IREDELL COUNTY HEALTH DEPARTMENT

IMPROVEMENT PERMIT / AUTHORIZATION TO CONSTRUCT / OPERATION PERMIT / EXISTING SYSTEM INSPECTION

PERMIT# 118600 PIN# ~~4626 36 4001 316~~ 4626286457.000 DATE 11/23/04

SUBDIVISION THE FARMS BLOCK / SECTION III LOT 316 LOT AREA .934C SITE CLASS RS DESIGN FLOW 450 L.T.A.R. .300/FT2

INITIAL SITE SKETCH 1"=50'

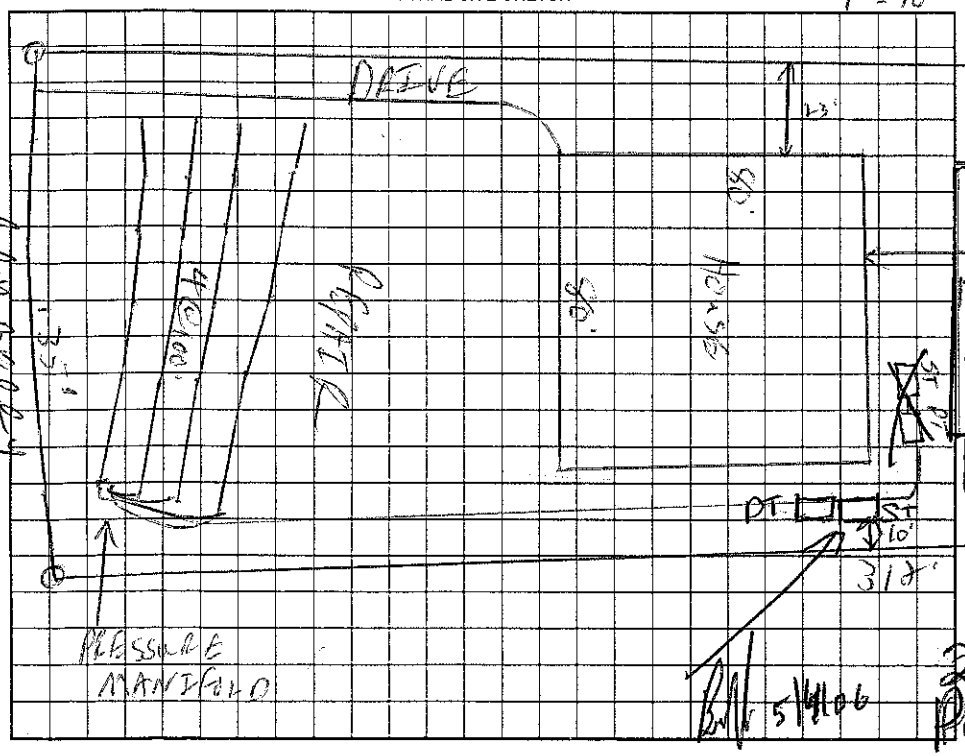
Comments/Conditions: ROAD NOT CONSTRUCTED AT TIME OF INSPECTION.
DO NOT CUT HOUSE SITE

AS BUILT SKETCH

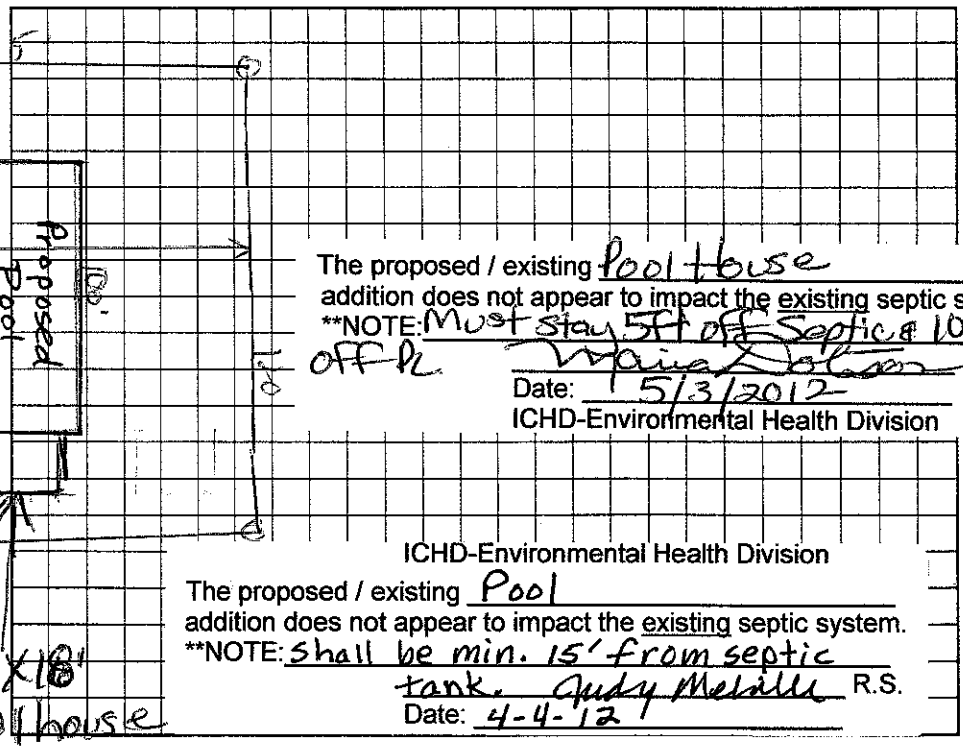
Comments/Conditions: 5/4/06 Installed EZ Flow as Drawn
Checked tanks after reset 5/4/06

The proposed / existing Pool House addition does not appear to impact the existing septic system
**NOTE: Must stay 5ft off Septic & 10ft off PL
Maria Dolan R.S.
Date: 5/3/2012
ICHD-Environmental Health Division

ICHD-Environmental Health Division
The proposed / existing Pool addition does not appear to impact the existing septic system.
**NOTE: Shall be min. 15' from septic tank. Judy Melillo R.S.
Date: 4-4-12
